ADDENDUM NO. 6

DATE: September 3, 2025

FROM: Matt Filla, PE, on behalf of the Town of Palisade

RE: Sewer Transfer Project

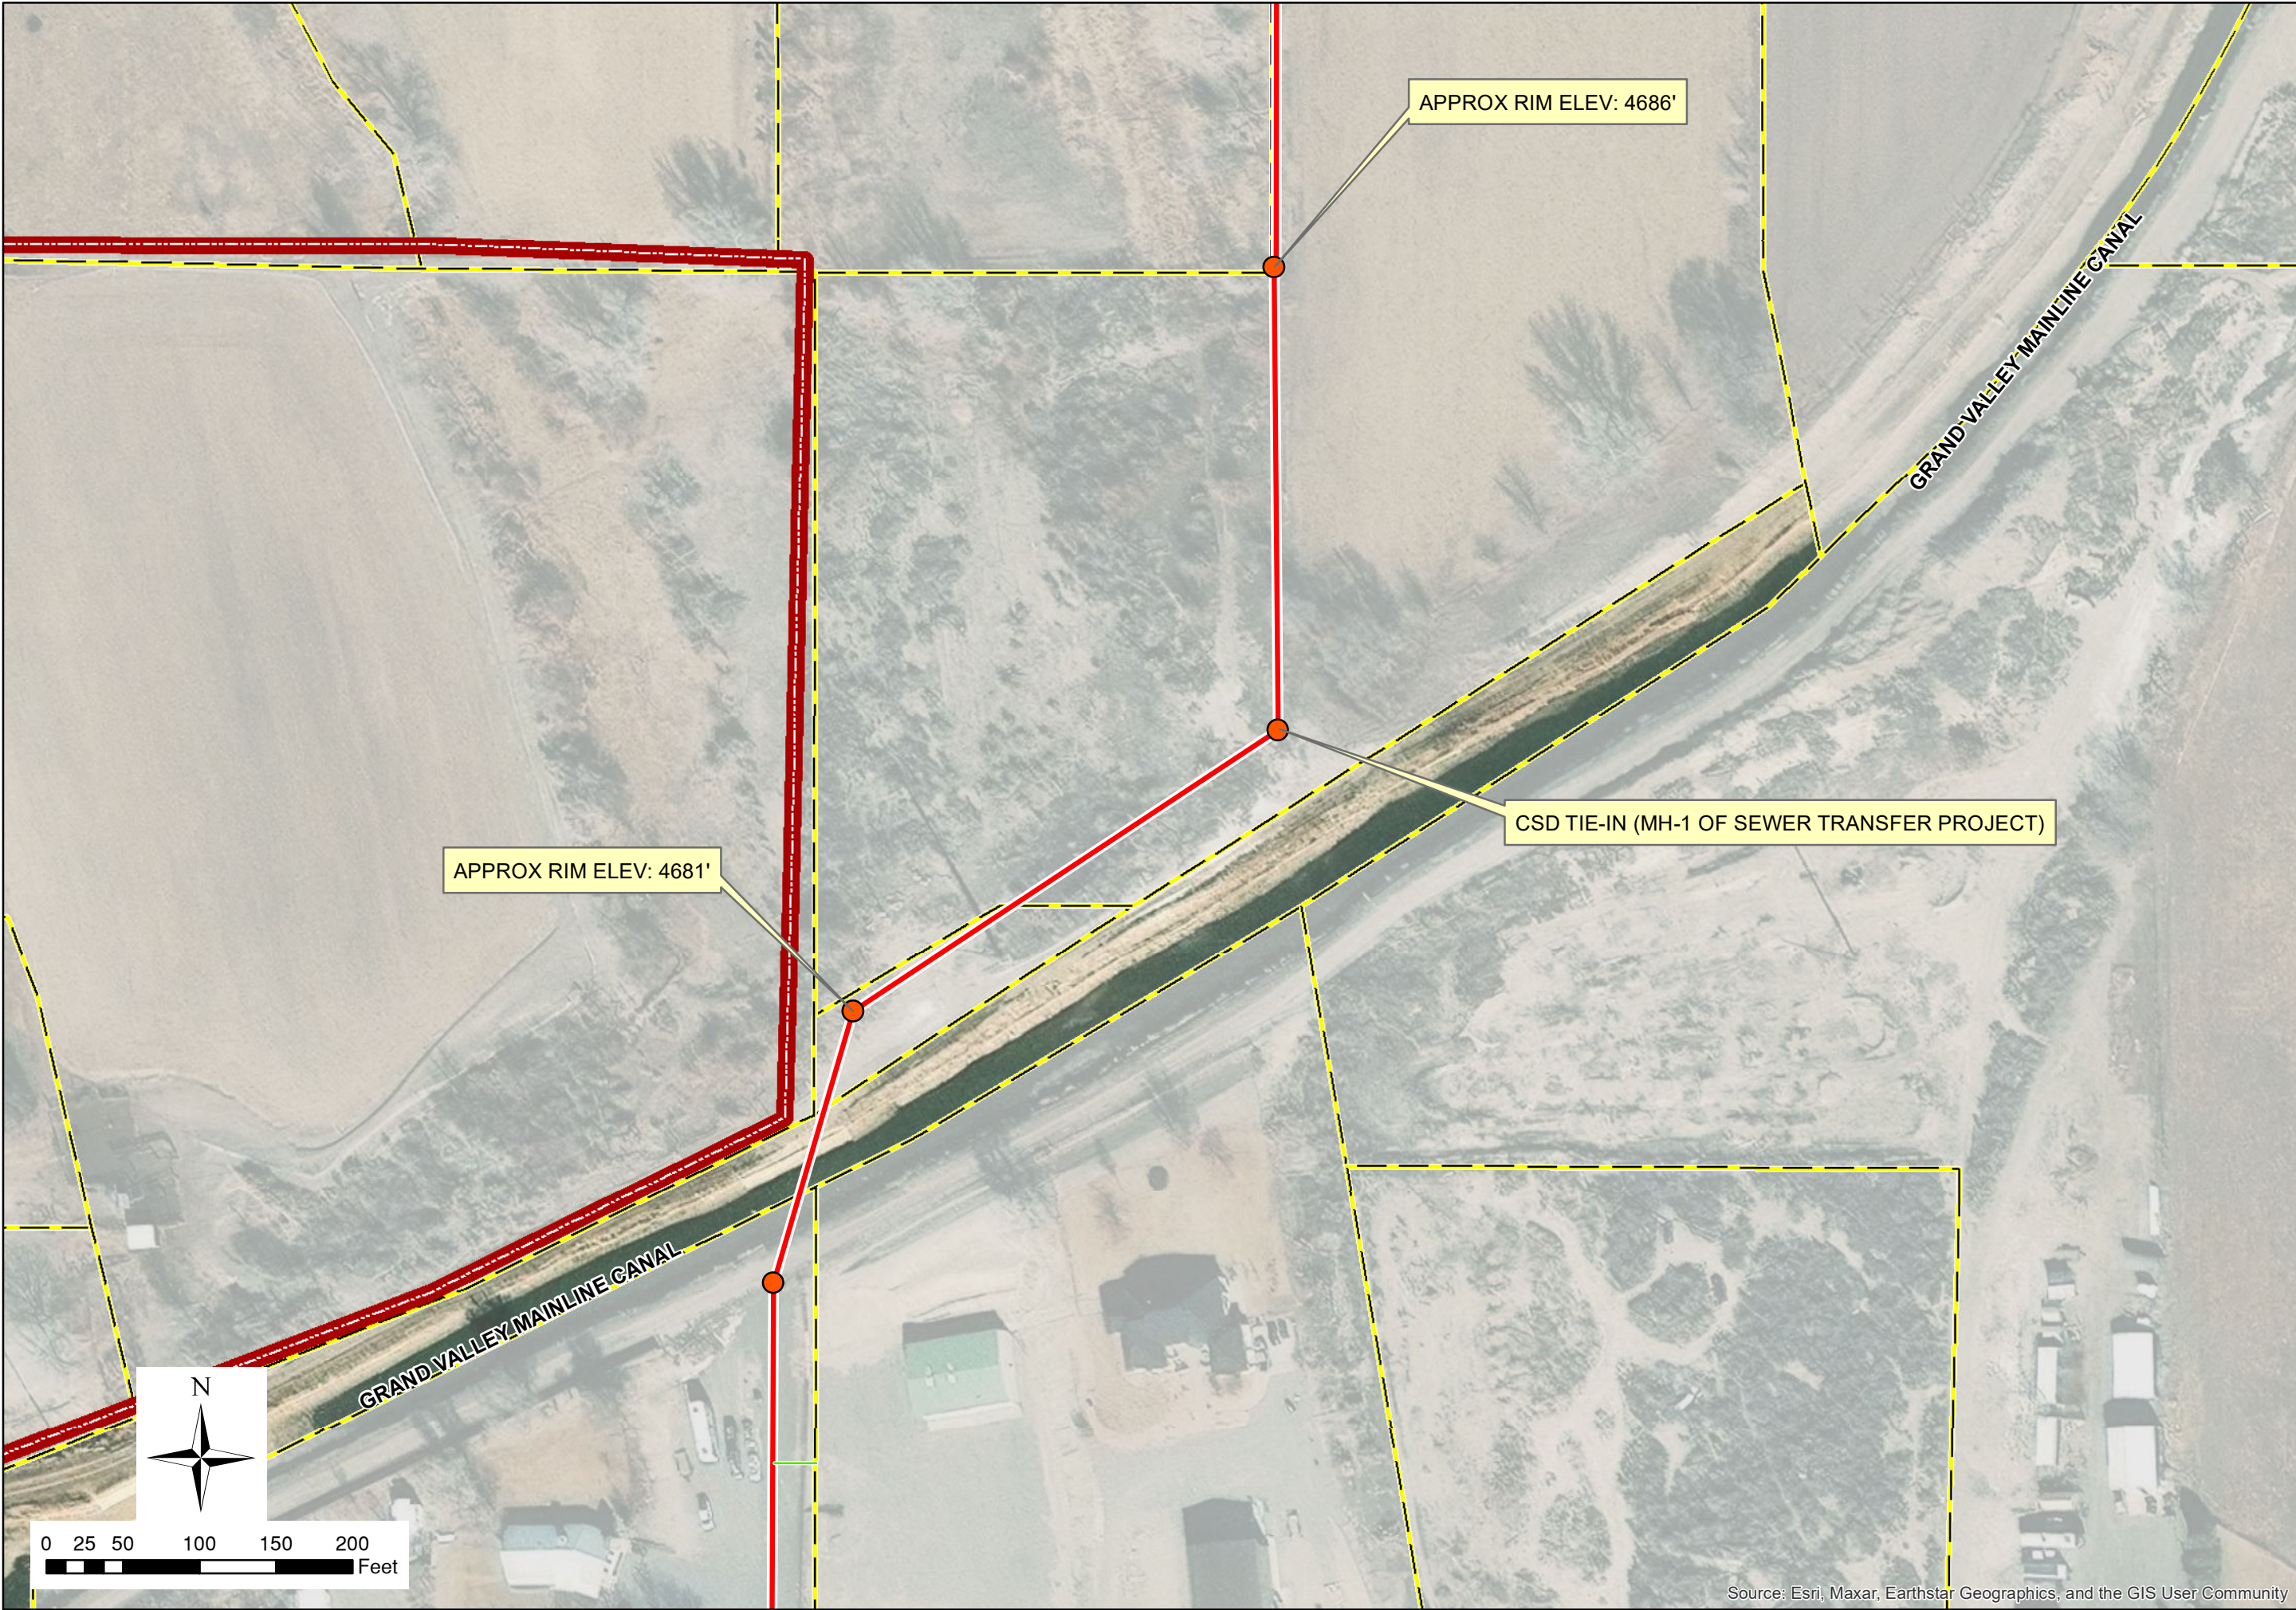
116. Question: "Both the lift station (sheet D-508) and the pigging station (Sheet C-501) shows a drain line to the wet well. Sheet C-101 & Sheet C-212 however does Not show wet well. Can you provide details and location of wet well?"

Response: Please see the D Sheets for the wet well layout and details. Attached is sheet C-101 marked up with additional clarification on the location of the drain lines and wet well.
